GRCA File: C14-25 & OPA3-25 - Ida Street

Re: Applications for Official Plan Amendment (OPA3-25) and Zoning By-law Amendment (C14-25)

Part Lot 234, Concession 2 (Southwest of Sydenham Road), Village of Dundalk
Owner: Briarwood (Dundalk) Ltd.
Agent: Innovative Planning Solutions c/o Dafne Gokcen

Figure 1: Model Schematic

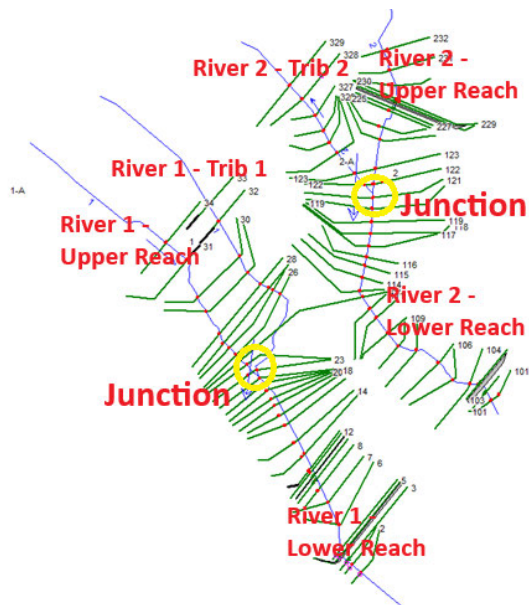
13. The modeled area two distinct rivers, each with three distinct reaches (tributary reach, upstream main reach, downstream main reach). However, these are modeled as four independent reaches and they do not interact. Junctions should be applied at the confluence of the river with the tributary for the two rivers. See figure below for where junctions should be applied and for locations of the different reaches.

17. The flows will need to be updated and clarified when the model geometry fixed. In the current model each reach has its own downstream boundary conditions. This means that each reach is acting completely independent of each other. There should only be two downstream boundary conditions, those for River 1 - Lower Reach and River 2 - Lower Reach (naming from Figure 1 above).

Figure 2- River 1 - Reach 1 and Reach

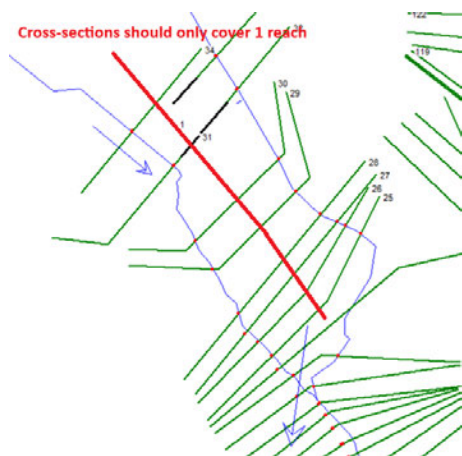
14. Cross-sections should only contain the channel for one reach and not extend into another reach. In the current model cross-section for each reach extend to into the adjacent reach. In figure 2 below, a red line has been drawn showing the approximate locations where cross-sections should end. Please correct the model accordingly.

15. In the current model, the entire river has been duplicated in in Reach 1 and Reach 1-A. For example, in the current model the culverts at River Stations 9.5 and 3.5 are included in both Reach 1 and Reach 1-A. Please correct the model accordingly.

16. Each reach should be acting independent of the other reach until they meet at the confluence, unless spill is occurring from one reach into the other. If a spill is occurring then lateral structures should be included to capture the spill and transmit that flow to the other reach. Please correct the model accordingly.
